<b>AMENDMENT OF SOLICITATION / MODIFICATION OF CONTRACT</b>			1. CONTRACT ID CODE	PAGE 1 OF PAGES 2
2. AMENDMENT/MODIFICATION NO. A00003	3. EFFECTIVE DATE 10/24/95	4. REQUISITION/ PURCHASE REQ. NO.		5. PROJECT NO. (If applicable) CIN-07
6. ISSUED BY U. S. Army Engineer District, New Orleans Corps of Engineers P.O. Box 60267 New Orleans, LA 70160-0267		7. ADMINISTERED BY (If other than Item 6)		
8. NAME AND ADDRESS OF CONTRACTOR (No., street, county, State and ZIP Code)  B & K Construction 1905 Highway 59 Mandeville, LA 70448			(X)	9A. AMENDMENT OF SOLICITATION NO.
				9B. DATED (See Item 11)
			X	10A. MODIFICATION OF CONTRACT/ ORDER NO. DACW29-94-C-0079
CODE OGTN3	FACILITY CODE			10B. DATED (See Item 13) 07/11/94

The following change is made to the above numbered contract for Lake Pontchartrain, LA & Vicinity, HLP, London Avenue Outfall Canal, Parallel Protection, Mirabeau Avenue to Leon C. Simon Boulevard Floodwall, Orleans Parish, LA, to revise the alignment of the floodwall from WB/L Station 70+47 to WB/L Station 84+54.77 and WB/L Station 85+90 to WB/L Station 99+83.67 to a position 4 feet to the flood side of the original alignment as requested by a Contractor Value Engineerin

PLAN AT EL. 11.0  
 CANAL SIDE

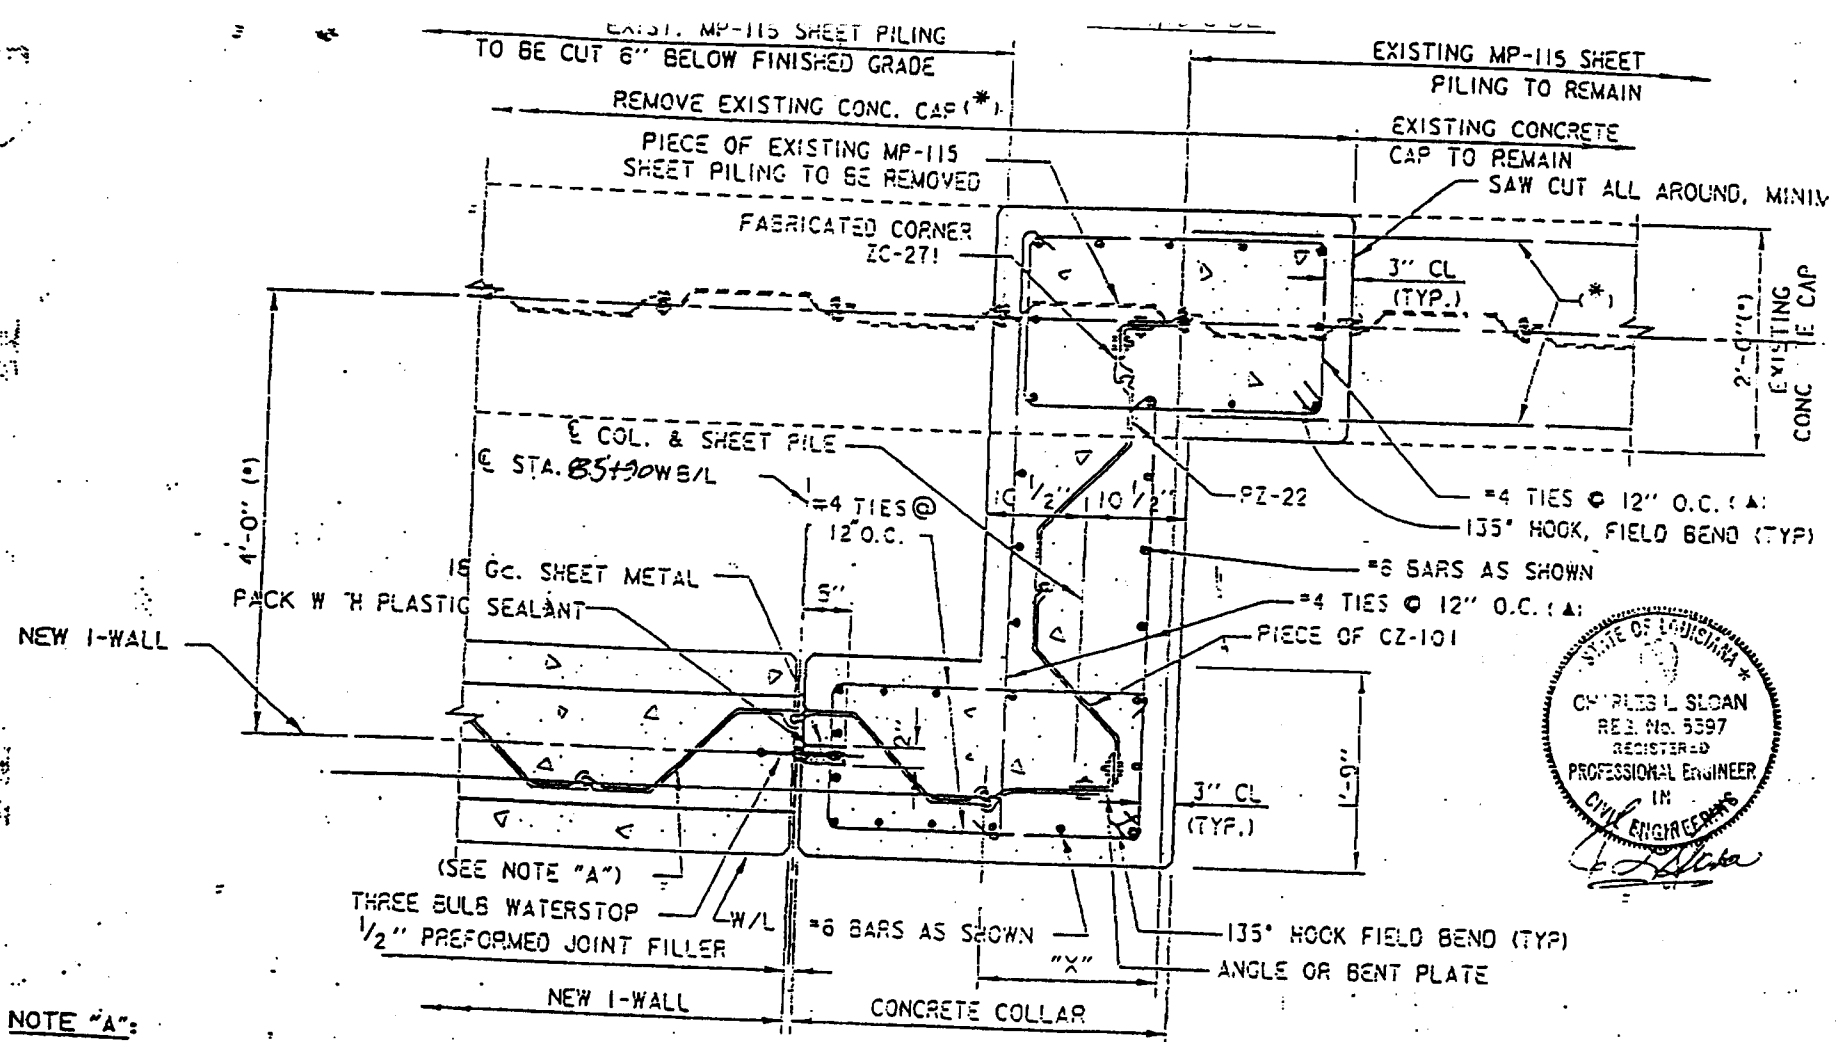
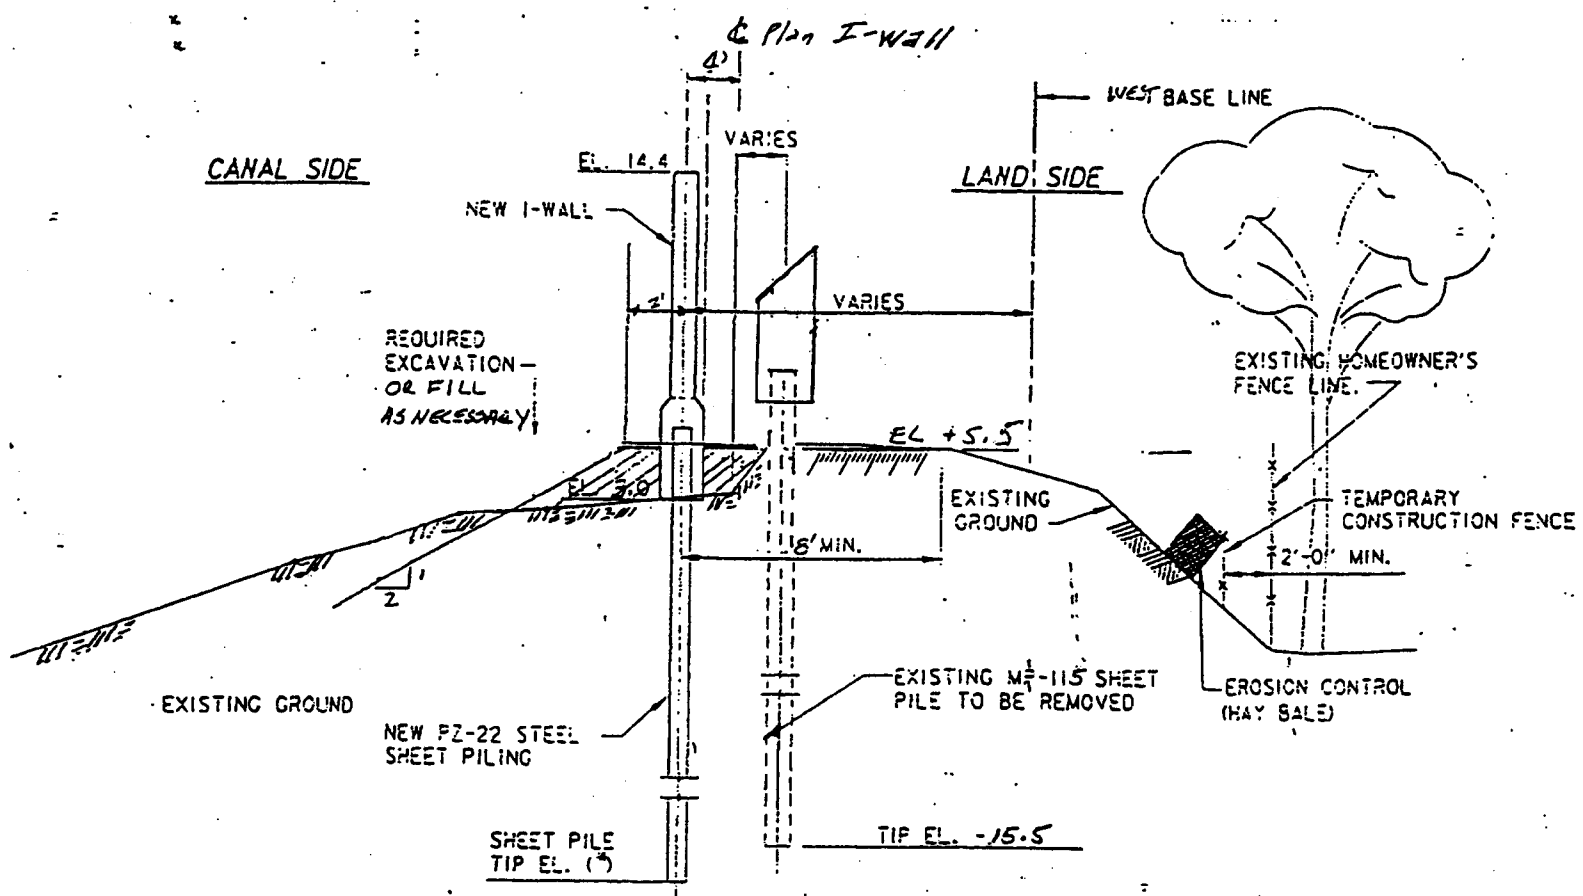
**CHANGES TO THE CONTRACT DRAWINGS:** Revise contract drawing 17 of 73, FILE NO. H-4-40295, dated March 1994, to include a detail of the revised alignment as shown on attached sketch SK-94-0079-01.

**NOTE "A":**  
 COLLAR TO INCLUDE AT LEAST ONE CZ 101 SO THAT WHEN COLLAR IS REMOVED FOR FUTURE I-WALL THERE IS A SHEET PILE TO INTERLOCK FUTURE SHEET PILING TO EXISTING SHEET PILING.

- (\*) EXPOSE AND CLEAN EXISTING LONGITUDINAL REBARS AND EXTEND THESE REBARS 1'-6" INTO THE NEW CONCRETE COLLAR.
- (A) ALL TIES ARE TO BE FIELD BENT.
- (B) #6 L-BARS TO LAP #6 BARS AS SHOWN IN PLAN AT EL. 5.00

NORTH END PLAN VIEW

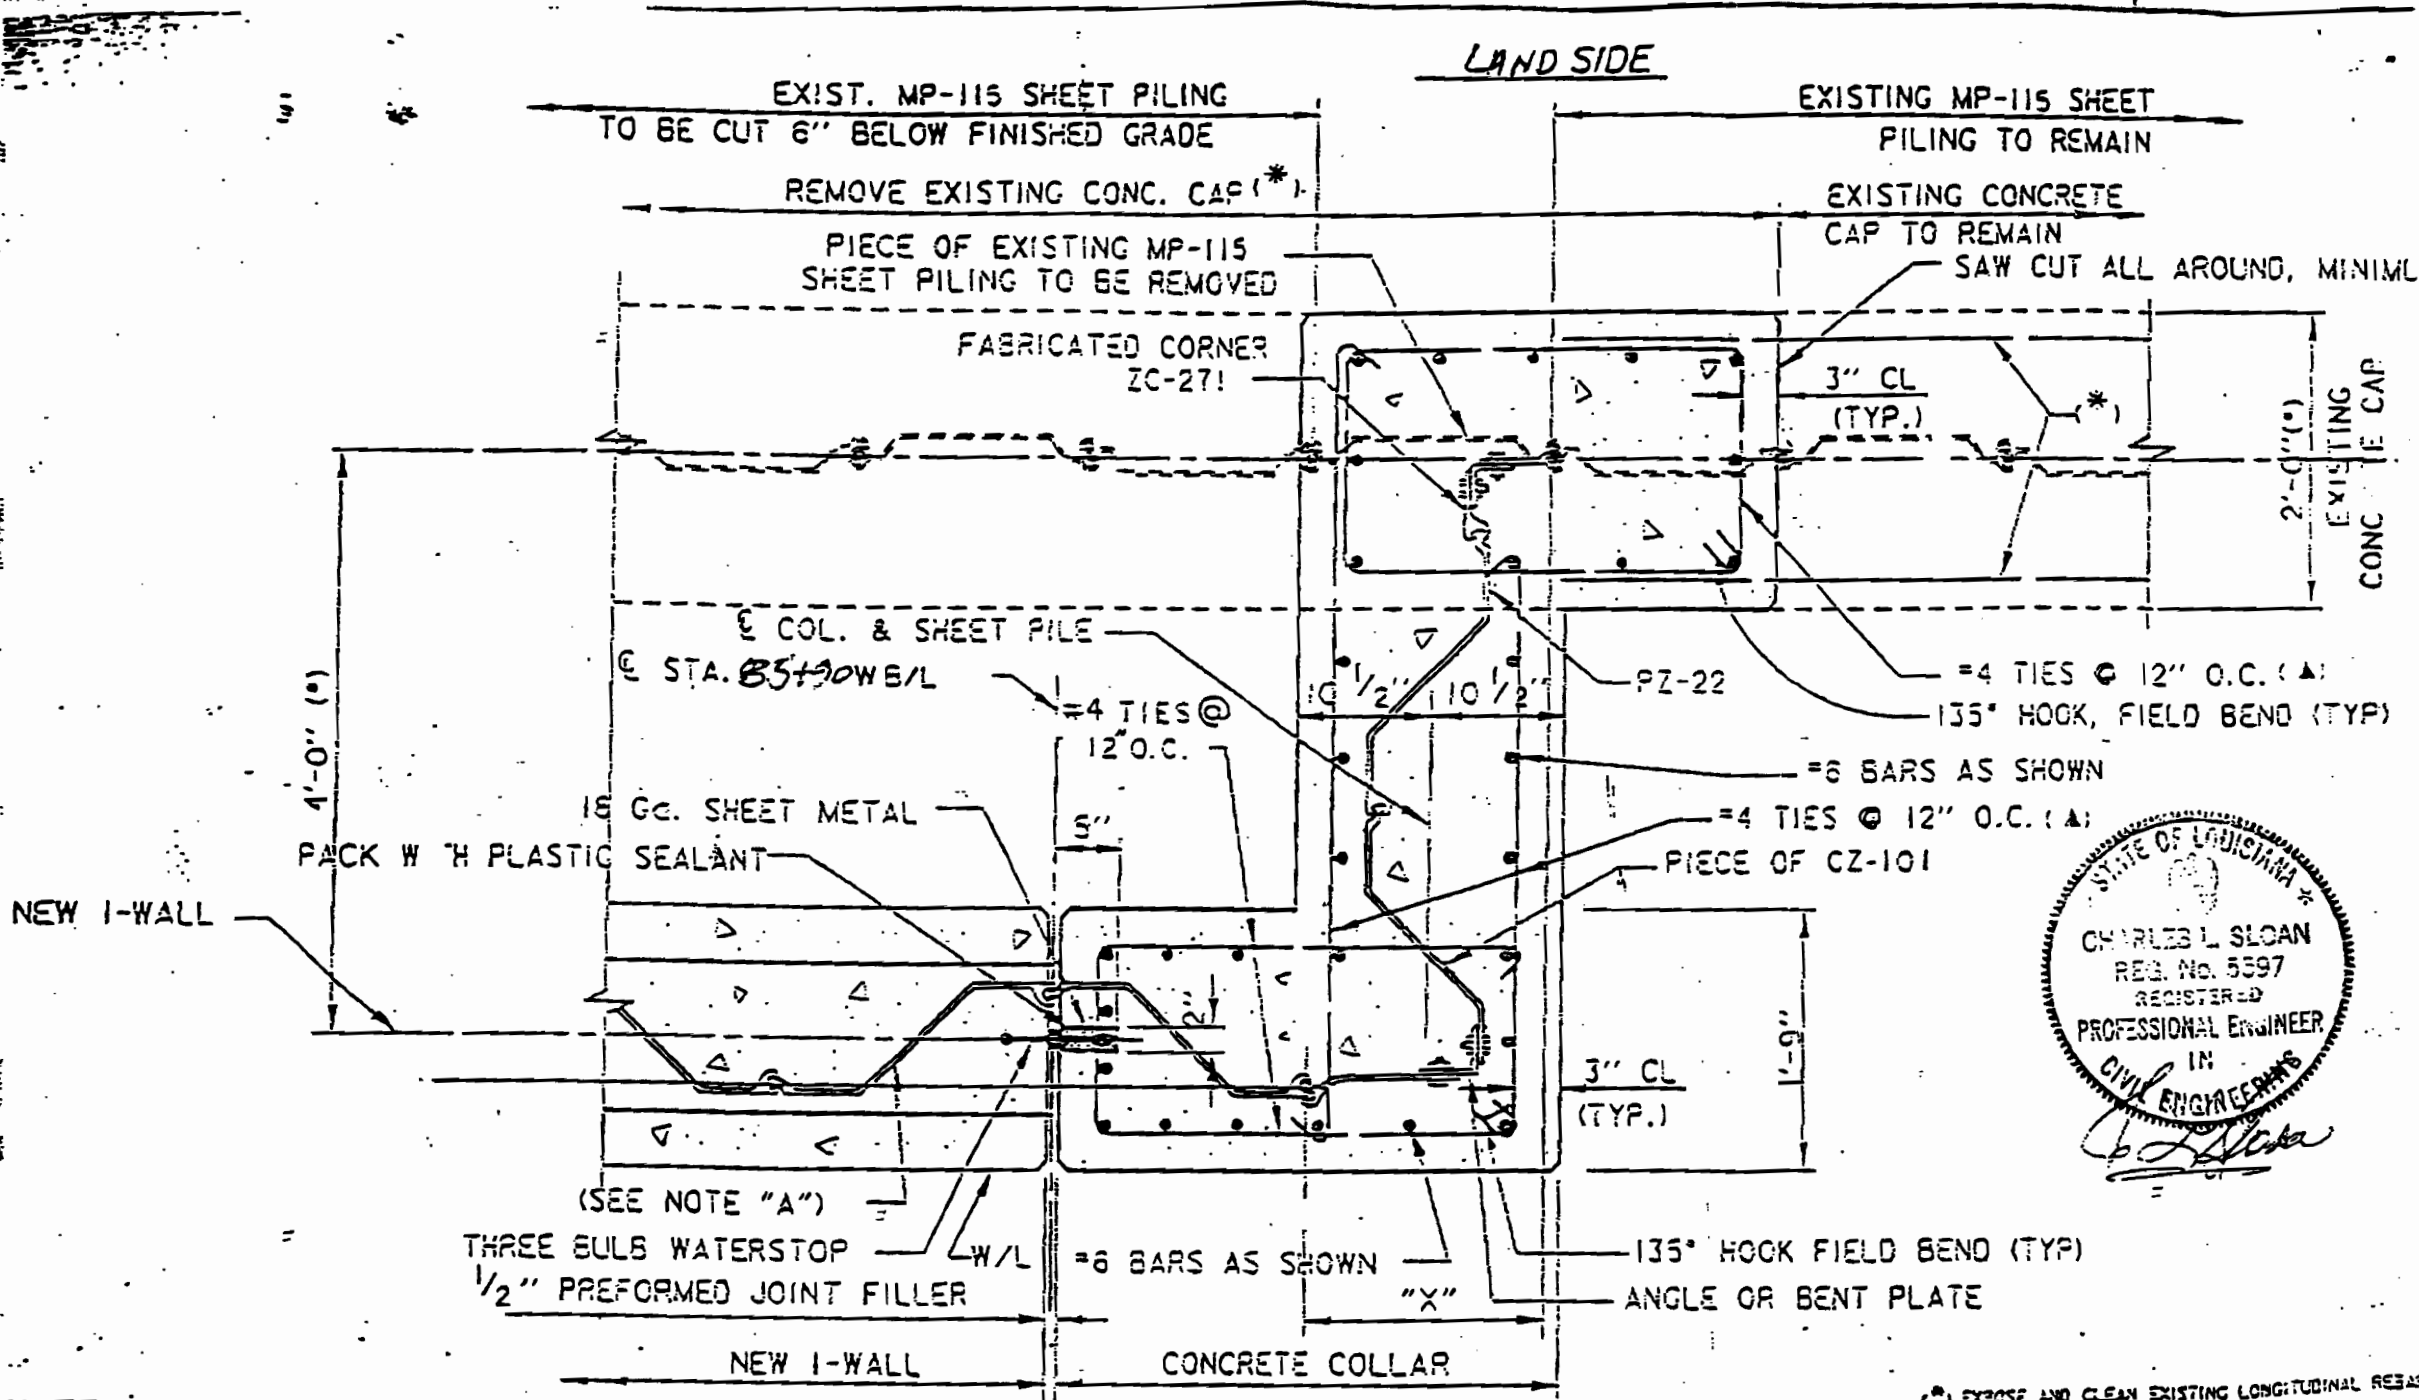
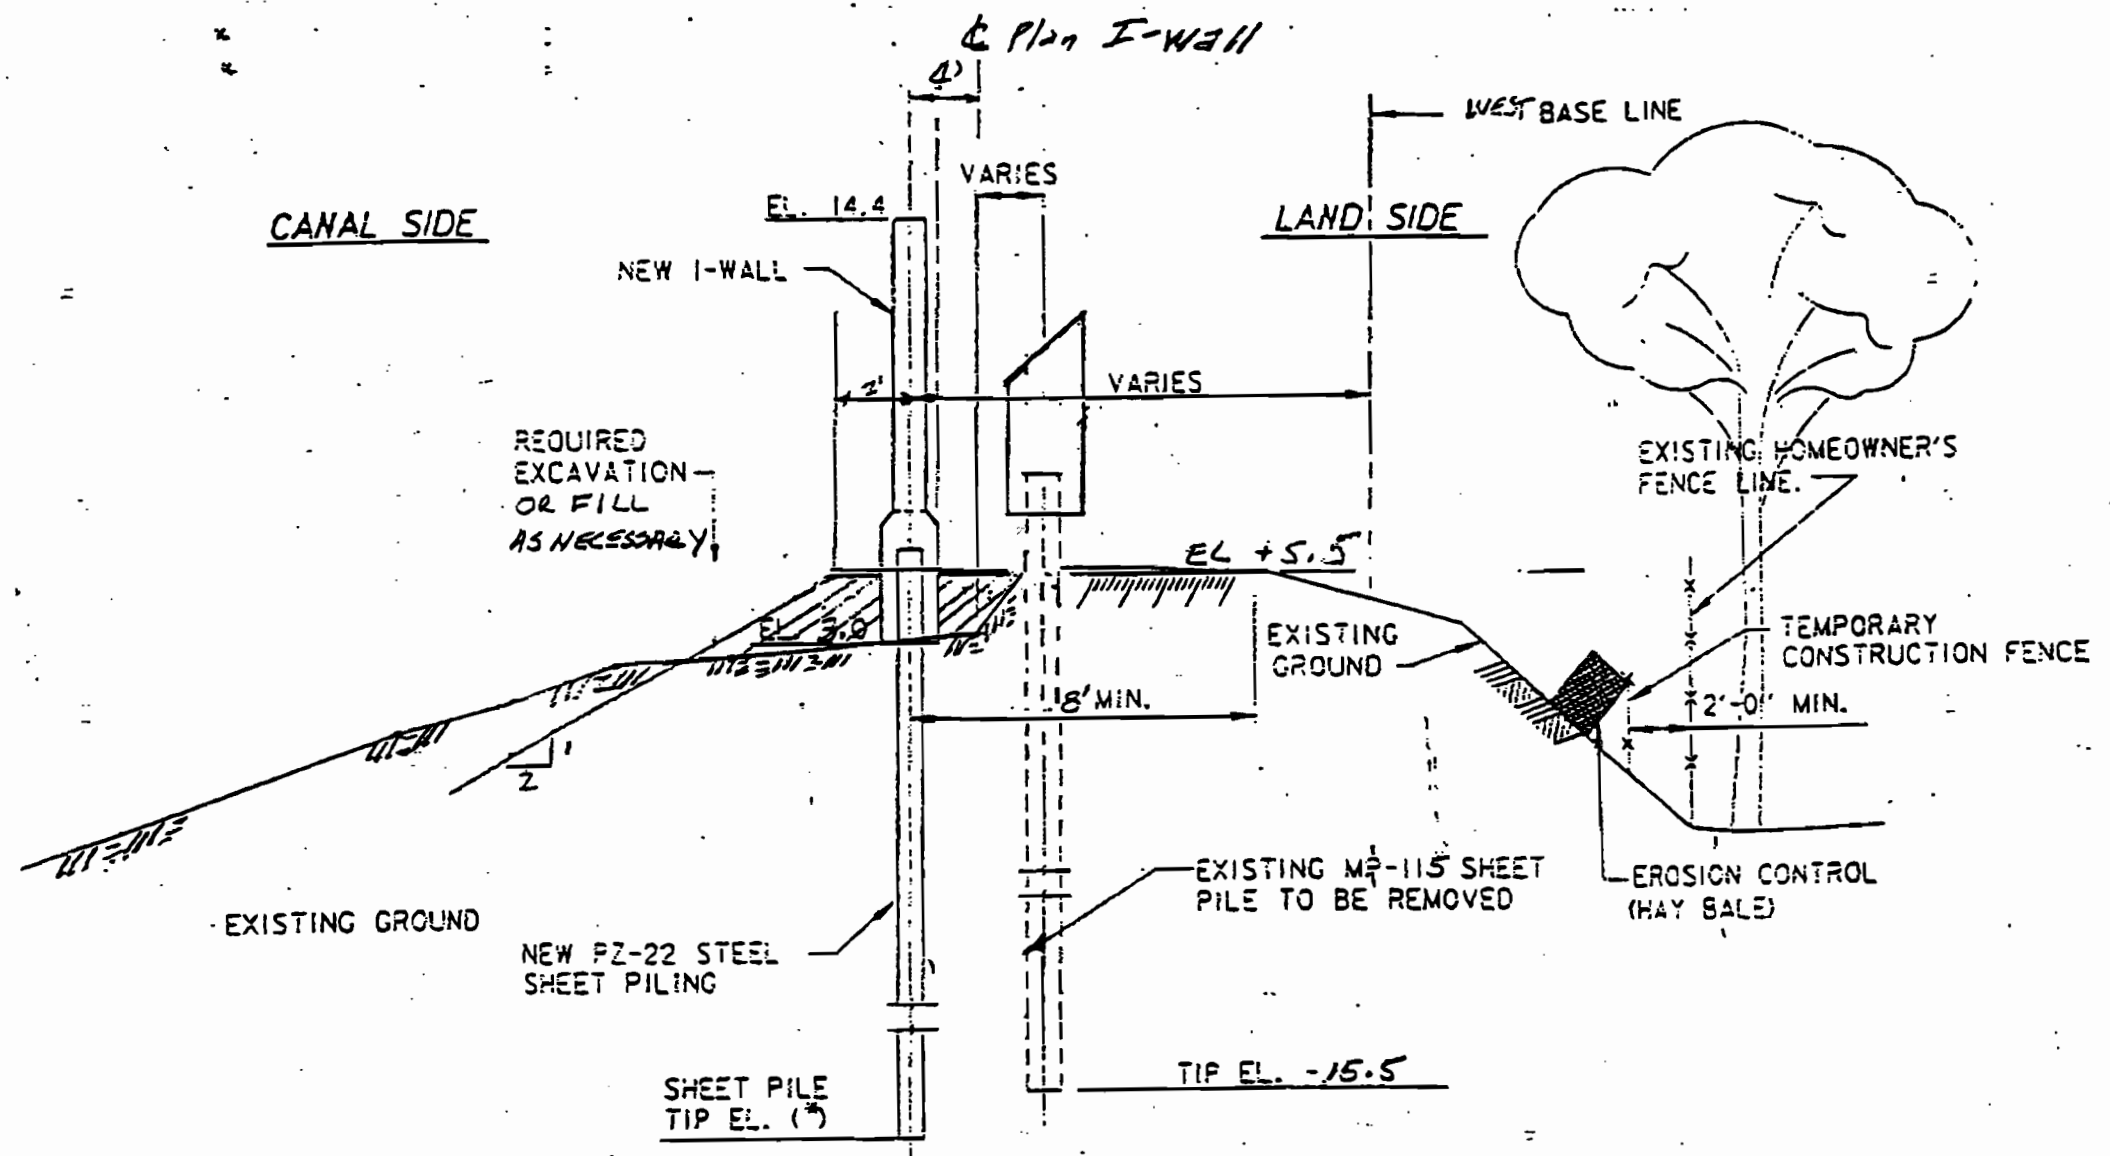
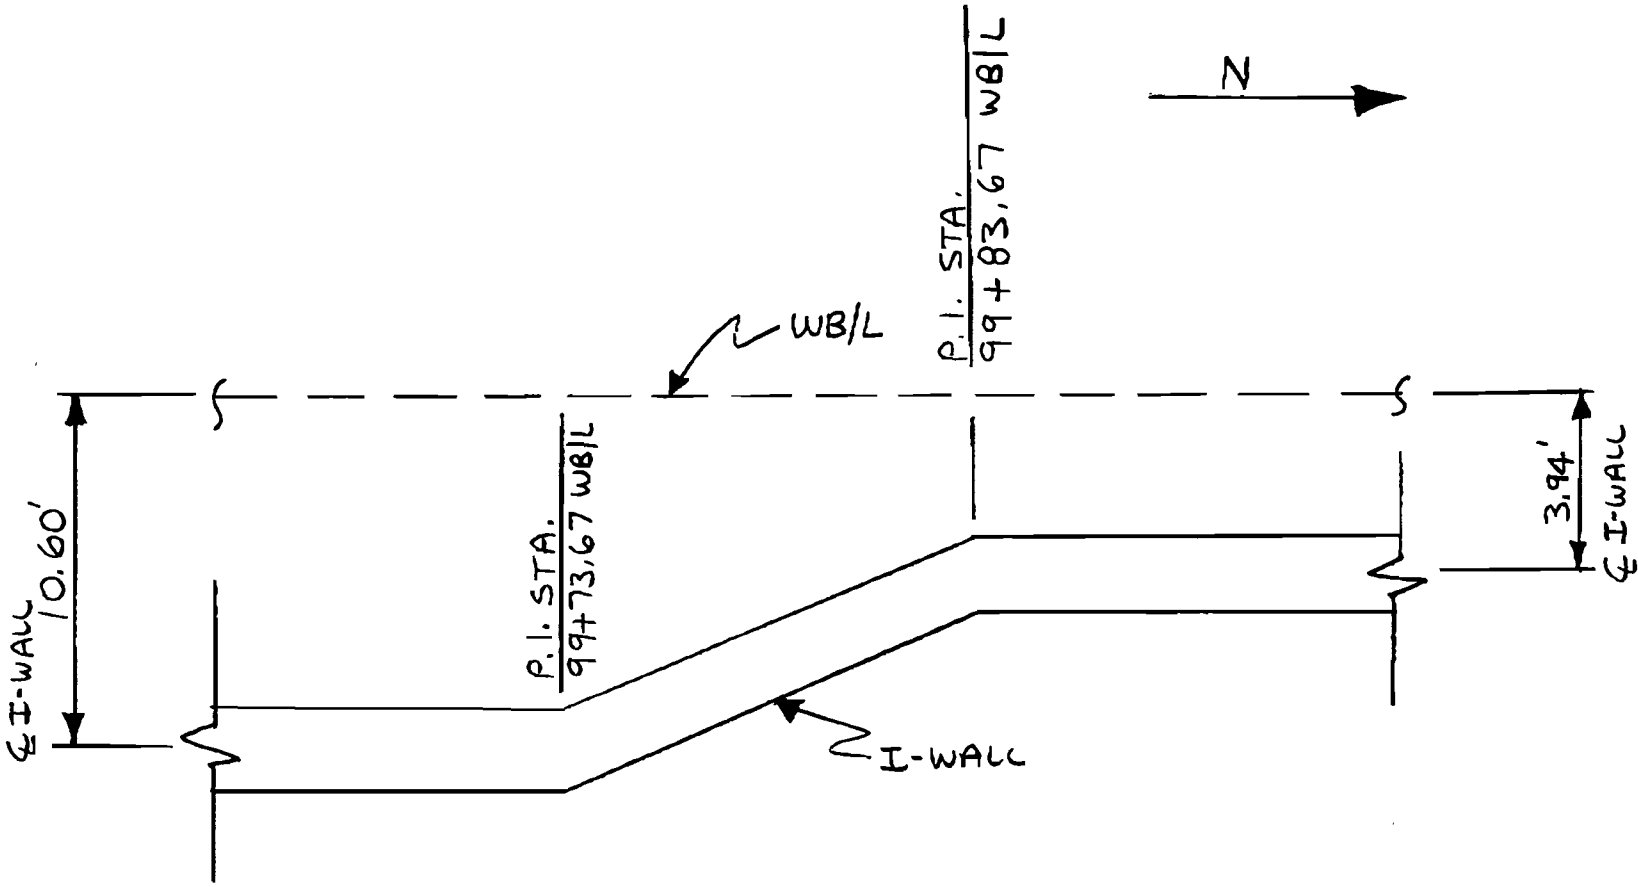
We propose to move the new I-Wall approximately 4'-0" to the floodside of the existing wall. This places the new wall 4' to the floodside of it's location on the original drawings. By moving the new I-Wall we can avoid the installation of temporary flood protection sheeting to elevation 6.75. We are prepared to offer the USCE a credit of 1/2 of \$5,565.50 or \$2,782.75 to allow us to make this plan change. Our costs break down as follows:

COLLAR TO INCLUDE AT LEAST ONE CZ 101 SO THAT WHEN COLLAR IS REMOVED FOR FUTURE I-WALL THERE IS A SHEET PILE TO INTERLOCK FUTURE SHEET PILING TO EXISTING SHEET PILING

- 1. EXPOSE AND CLEAN EXISTING LONGITUDINAL REBARS AND EXTEND THESE REBARS 1'-8" INTO THE NEW CONCRETE COLLAR.
- 2. ALL TIES ARE TO BE FIELD BENT.
- 3. #6 L-BARS TO LAP #6 BARS AS SHOWN IN PLAN AT

1. The contractor's proposal for changing the wall alignment between Sta. 70+47 and Sta. 84+54.77 WB/L is technically acceptable. This VECP has been assigned CIN 06, and any further correspondence regarding this change should reference this number.
2. Request you take the necessary actions for completion of modification. Furnish a copy of the finalized modification to the Value Engineering Officer.
3. POC is Jim Berry at ext 1240.
